Project	IEEE 802.16 Broadband Wireless Access Working Group < http://ieee802.org/16 >	
Title	Comment on Relay Frame Structure	
Date Submitted	2008-12-24	
Source(s)	Kanchei (Ken) Loa, Yi-Hsueh Tsai, Chun-Yen Hsu, Chiu-Wen Chen, Tsung-Yu Tsai Institute for Information Industry (III)	Voice: +886-2-66000100 Fax: +886-2-66061007 loa@iii.org.tw , lucas@iii.org.tw
Re:	IEEE 802.16m-08/052: Call for Comments on Project 802.16m System Description Document (SDD)	
Abstract	Proposed Text of Relay Station Frame Structure for the IEEE 802.16m SDD	
Purpose	We propose relay station frame structure	
Notice	<i>This document does not represent the agreed views of the IEEE 802.16 Working Group or any of its subgroups. It represents only the views of the participants listed in the "Source(s)" field above. It is offered as a basis for discussion. It is not binding on the contributor(s), who reserve(s) the right to add, amend or withdraw material contained herein.</i>

Comment on Relay Frame Structure

Kanchei (Ken) Loa, Yi-Hsueh Tsai, Chun-Yen Hsu, Chiu-Wen Chen, Tsung-Yu Tsai

Figure xxx Relay Frame structure

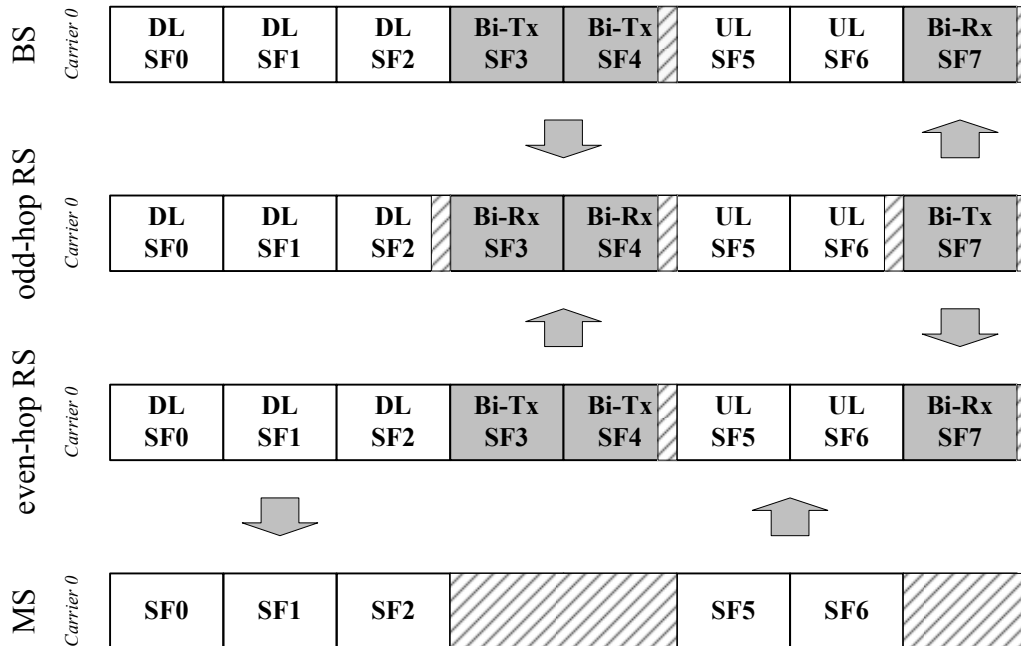
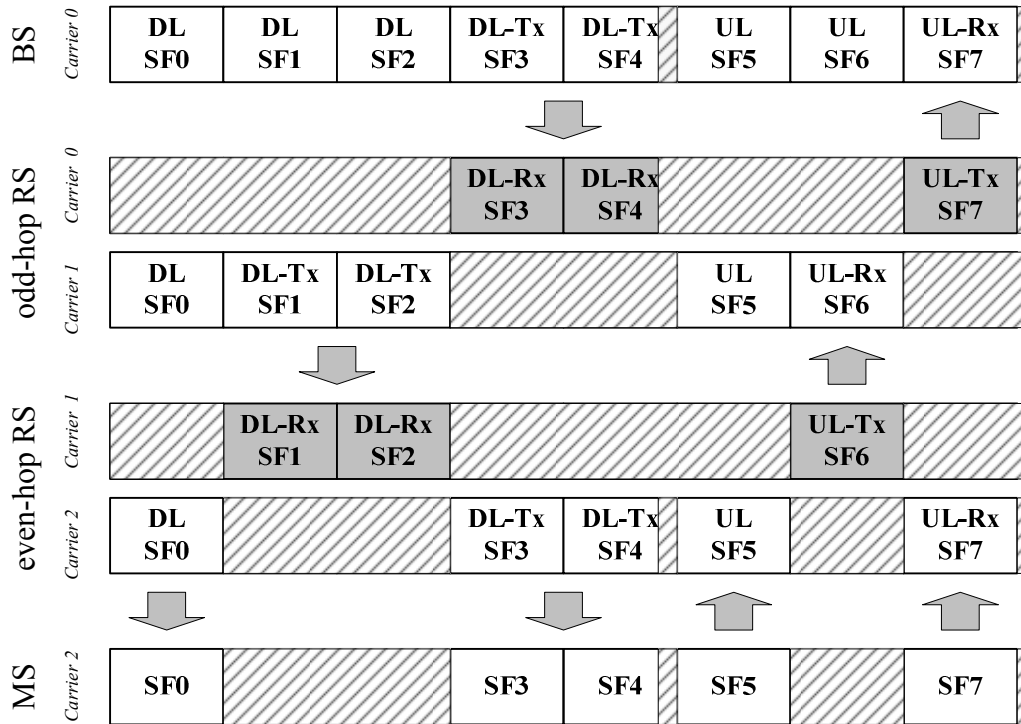
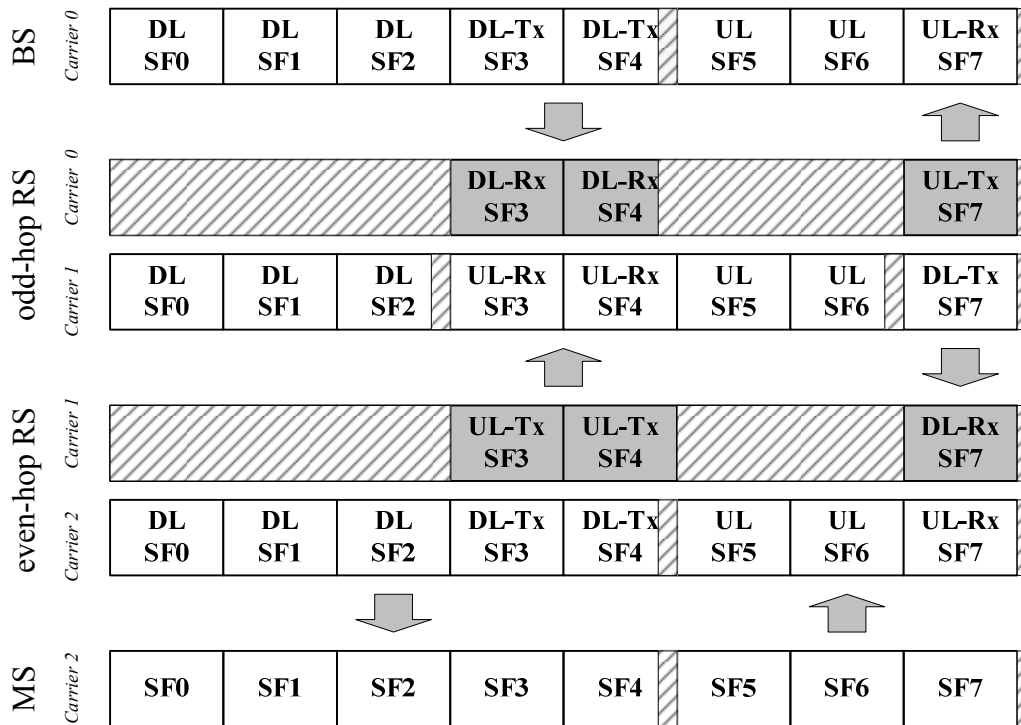
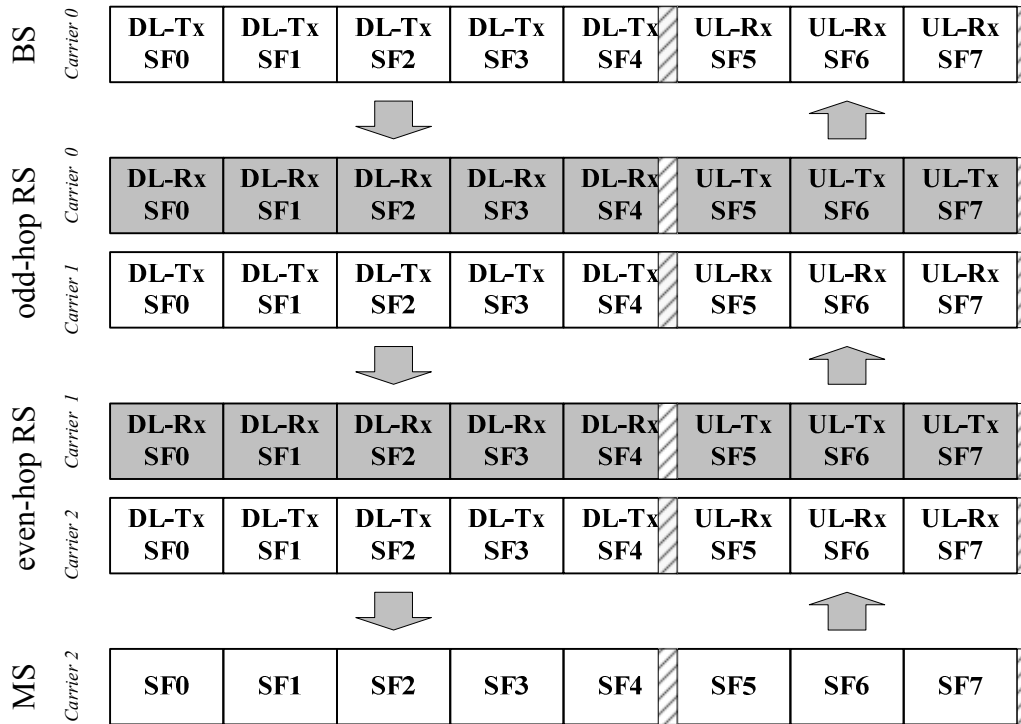
After working on detailed subframe definitions for the access zone and the relay zone, we discovered that, unlike the 16j frame structure, those zone definitions are not required for defining 16m relay frame structure. This contribution proposes an alternative subframe-based relay frame structure that dramatically simplifies current relay frame structure definitions and accommodates both Option 1 and Option 2; such that there is one unified relay frame structure defined in the SDD regardless “the decision on Option 1 & 2”. Additionally, examples of detailed subframe descriptions for the relay operating on single carrier and dual carriers are included to facilitate the on-going discussion on the bi-directional relay. A dual-carrier bidirectional Tx/Rx relay, which utilizes the 16m basic frame structure, is depicted in Figure xxx(d) as an alternative to the single-carrier bidirectional Tx/Rx relay (Figure xxx(b)).

Depending on the capability of the RS (such as number of transceivers), there are five examples of relay frame structures captured in Figure xxx.

[Replace the text in line 20 of page 67 to line 3 of page 71 by the following text:]
